## Product / Process Change Notification (PCN)

<b>PCN Number:</b> PCN_UtLAN_20240902  <b>Affected Series:</b> WE-LAN  <b>Affected Order Codes:</b> 749012013, 749020015, 7490100111, 749022011  <b>PCN Date:</b> 2024-06-02 (YYYY-MM-DD) <b>Effective Date:</b> 2024-09-02 (YYYY-MM-DD)	<b>Change Category:</b> <input checked="" type="checkbox"/> Equipment/Location <input checked="" type="checkbox"/> General Data <input checked="" type="checkbox"/> Material <input type="checkbox"/> Process <input checked="" type="checkbox"/> Product Design <input checked="" type="checkbox"/> Shipping / Packaging <input type="checkbox"/> Supplier <input type="checkbox"/> Software				
<b>Contact:</b> Product Management <b>Phone:</b> +49 (0) 7942 - 945 5001 <b>Fax:</b> +49 (0) 7942 - 945 5179 <b>E-Mail:</b> pcn.eisos@we-online.com	<b>Datasheet Change:</b> <input checked="" type="checkbox"/> Yes <input type="checkbox"/> No  <b>Attachment:</b> <input type="checkbox"/> Yes <input checked="" type="checkbox"/> No				
<b>Description of Change:</b> Due to internal standardisation, Würth Elektronik eiSos will move the production to new production line. The packaging as well as product marking will be changed, the dat

**Affected order code: 749012013.**

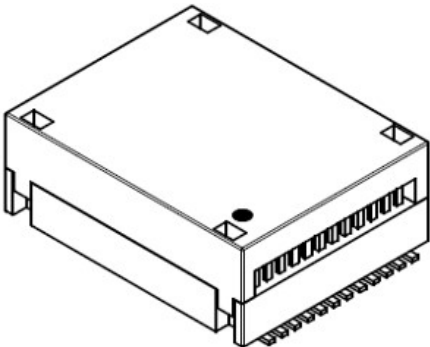
Before change	After change
 <p data-bbox="379 929 560 958"><b>L-form housing</b></p>	 <p data-bbox="981 936 1193 965"><b>Gull-wing housing</b></p>

**Affected order code: 749020015.**

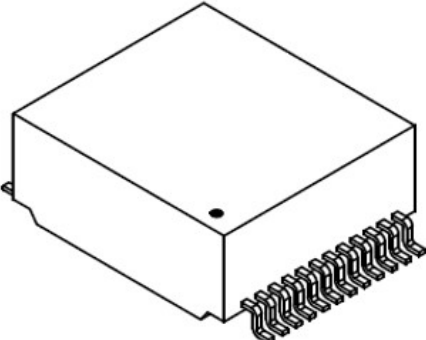
Before change	After change
 <p data-bbox="379 1534 560 1563"><b>L-form housing</b></p>	 <p data-bbox="981 1534 1193 1563"><b>Gull-wing housing</b></p>

4. **Marking change:**

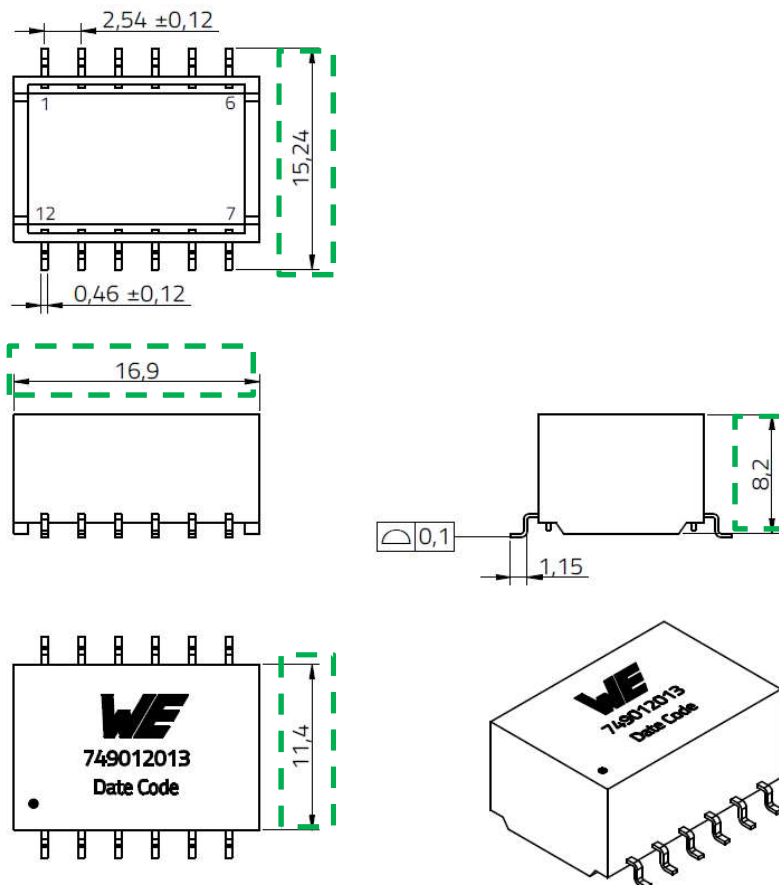
order code	Before change	After change
749012013		
749020015 (000-7330-30R-LF1)		
7490100111 (000-7430-30R-LF1)		
749022011

order code: 749012013

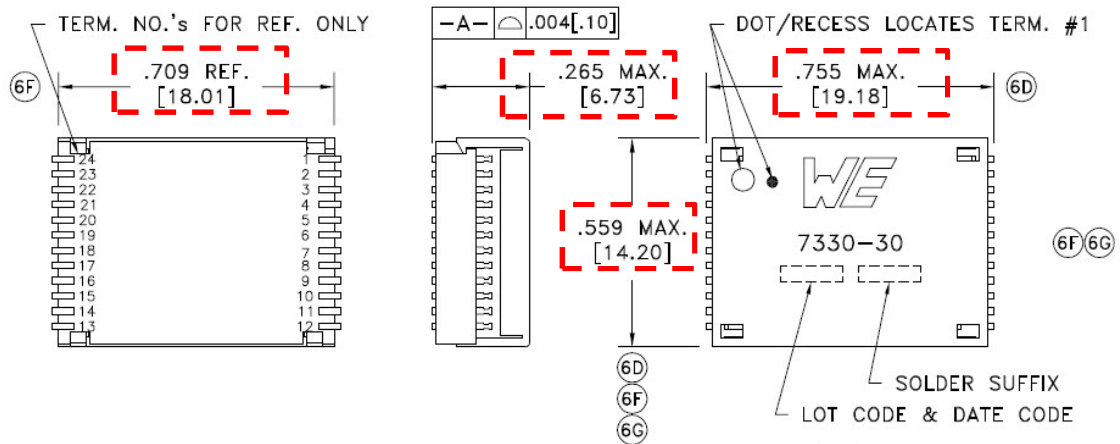
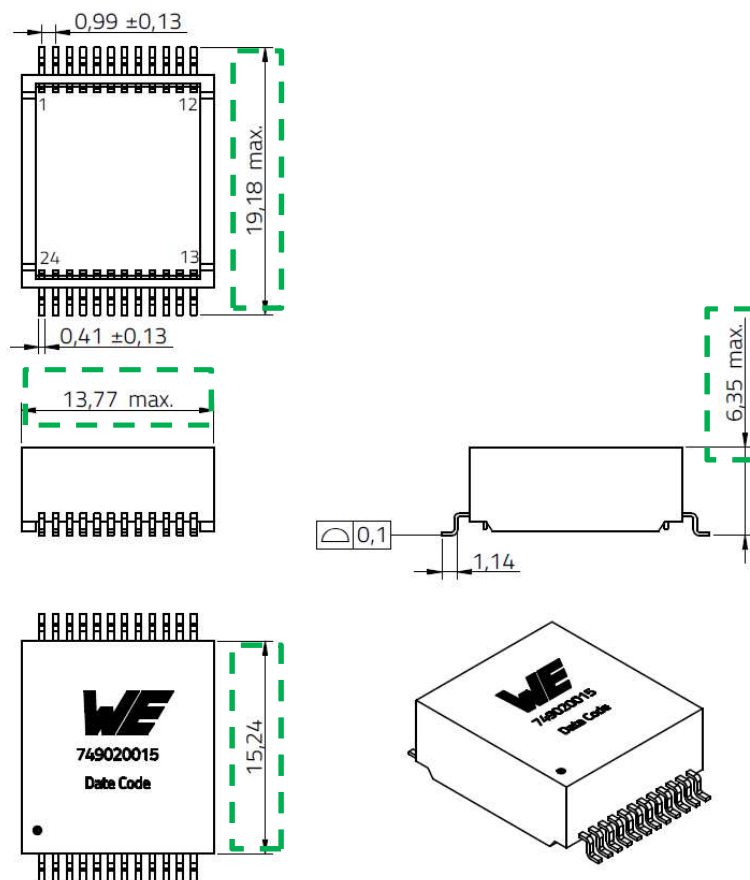
### 5. Datasheet correction:

#### Before change:

#### After change:

**order code: 749020015**

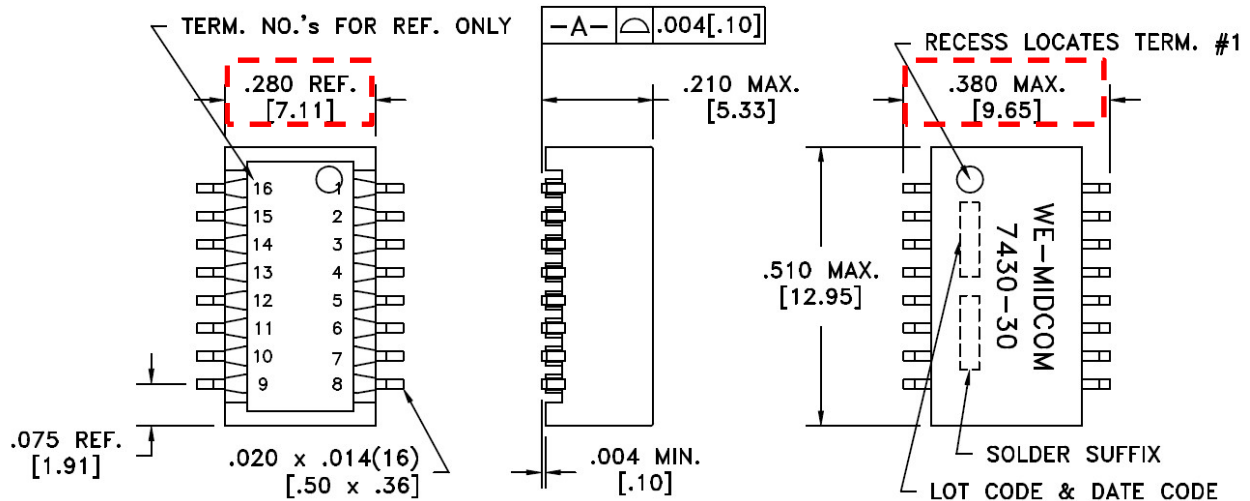
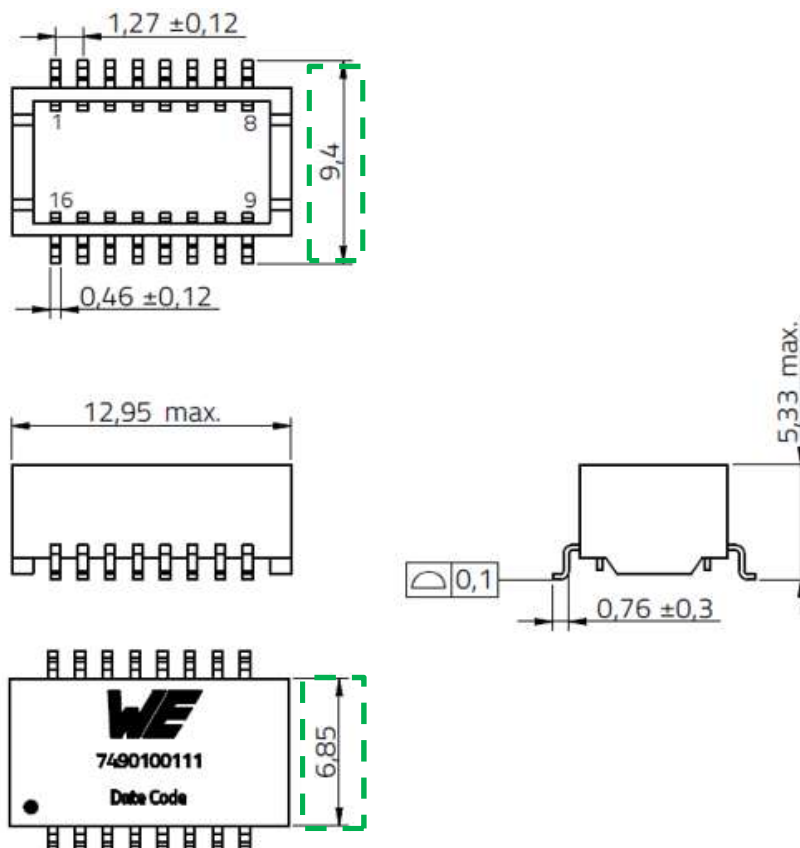
**Before change:**

**After change:**

order code: 7490100111

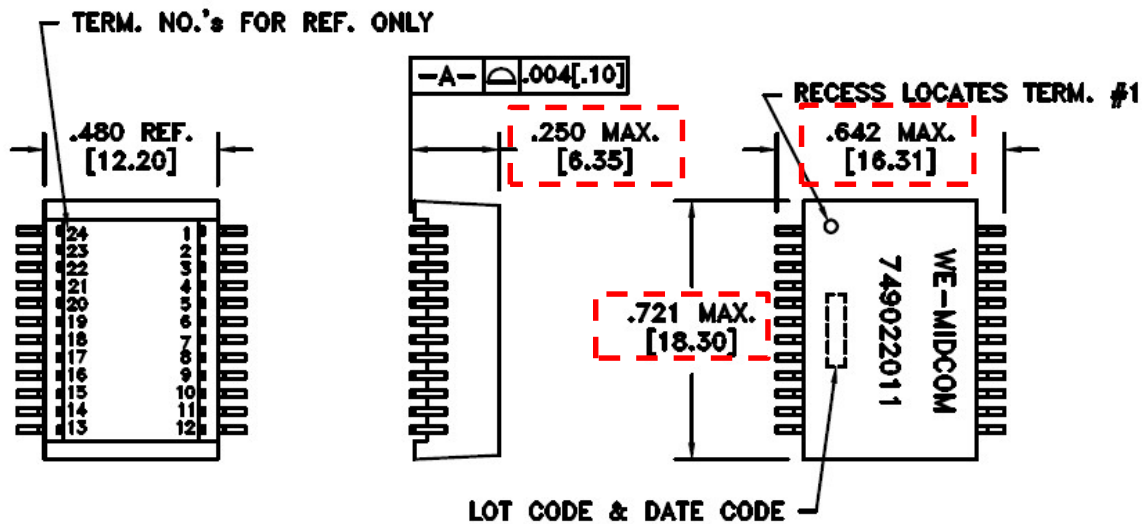
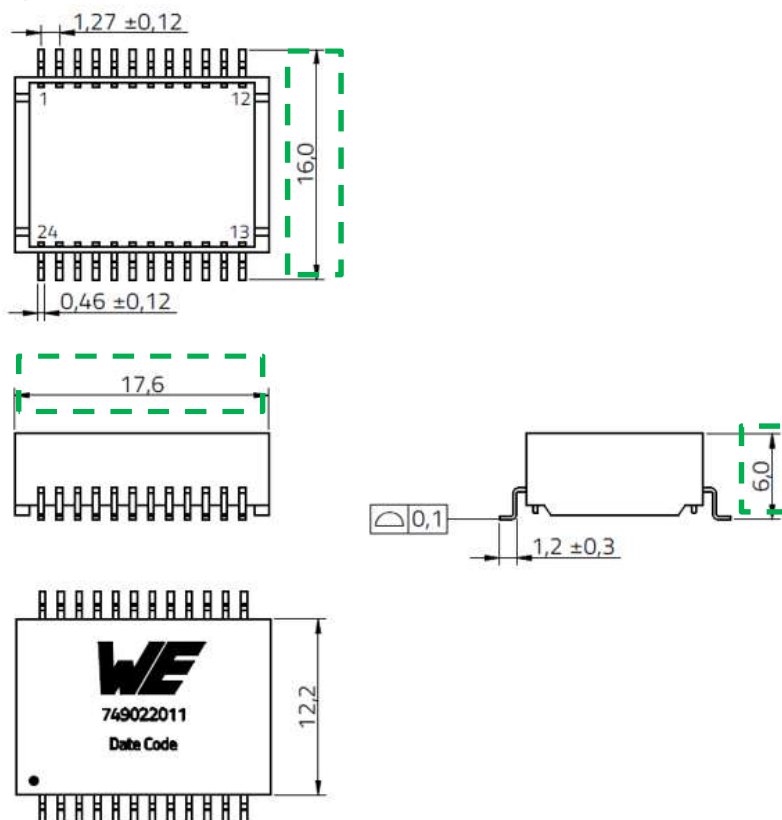
**Before change:**

**After change:**
